UNITED STATES PATENT AND TRADEMARK OFFICE

APPLICATION NO.	FILING DATE	FIRST NAMED INVENTOR	ATTORNEY DOCKET NO.	CONFIRMATION NO.
10/585,722	06/26/2008	Peter Georg Laitenberger	568-PDD-03-13-US-[58P]	7200
69683	7590	01/05/2012		
C. R. Bard, Inc. Bard Peripheral Vascular, Inc. 1415 W. 3rd St PO Box 1740 Tempe, AZ 85280-1740			EXAMINER WOZNICKI, JACQUELINE	
			ART UNIT 3774	PAPER NUMBER
			NOTIFICATION DATE 01/05/2012	DELIVERY MODE ELECTRONIC

Office Action Summary	Application No. 10/585,722	Applicant(s) LAITENBERGER ET AL.	
	Examiner JACQUELINE WOZNICKI	Art Unit 3774

DETAILED ACTION

Annotated Figure 10

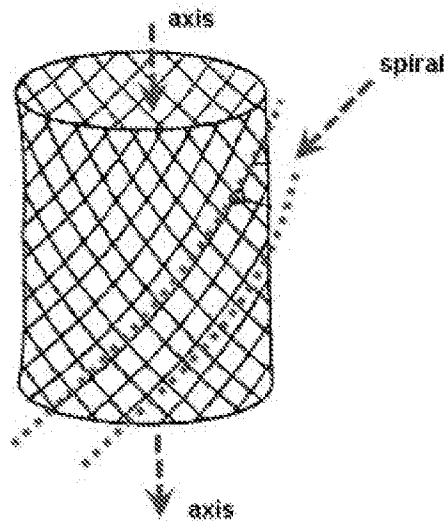
Examiner respectfully disagrees and notes that the spiral/helically wound loops are not arbitrarily drawn in by Examiner, but that the loops (which are understood to be each loop (Figure 3, items 132, 134, 136, 138), arranged within a mesh structure, which is clearly shown to be a diagonal mesh. Examiner notes further that a diagonally oriented mesh, which is curved into a tubular shape (such as is shown in Figure 10), *does* result in its loops that make up the mesh being helically wound around the longitudinal axis that is created within the tubular shape when the mesh is curved.

Examiner respectfully disagrees, noting that Gray teaches the conductive strands (221) forming just about any pattern ([0099]), and that Figure 10 shows the pattern of

the strands indicating a helically wound configuration. Examiner is not sure how Applicant's arguments with respect to the conductors realizing immunity from EMF interference or insult supports their arguments with respect to the arrangement of closed loops, and so does not consider this persuasive.

Regarding **claims 1 and 6-7**, Gray discloses an implant comprising:

a tubular metal stent (Figure 3 (tubular); Abstract (metal); [0018] (stent))
defining a lumen centered on a central longitudinal axis (Annotated Figure 10; "axis"), **the stent being radially expansible from a radially compact delivery configuration to a radially larger deployed configuration** ([0114]),
a plurality of electrically-conductive closed loops comprising struts forming an apertured wall of the stent (Figure 3, items 132, 134, 136, 138 (loops) and [0095]; the curved segment loops form the meshed wall of the stent. The struts are the "strands", Figure 10 item 221.),

said loops being helically wound around the longitudinal axis

(Annotated Figure 10),

each of said loops being formed from strut loop portions (Figure 1, items 102, 104) **providing electrically-conductive current pathways within which eddy currents are liable to be induced when subjected to a time-dependent external magnetic field** (Figure 1, item 110, 112), **each of said loops including a first current pathway and a second current pathway** ([0076]) **wherein said first current pathway and said second current pathway are arranged such that, regardless of the direction of said external magnetic field, the direction of the eddy current that would be induced by said field in said second current pathway is the reverse of the direction of the eddy current that would simultaneously be induced by said field in said first current pathway, thereby to prevent flow of eddy currents in each of said loops, thereby mitigating a Faraday Cage effect and rendering the lumen visible to MRI** (Abstract)
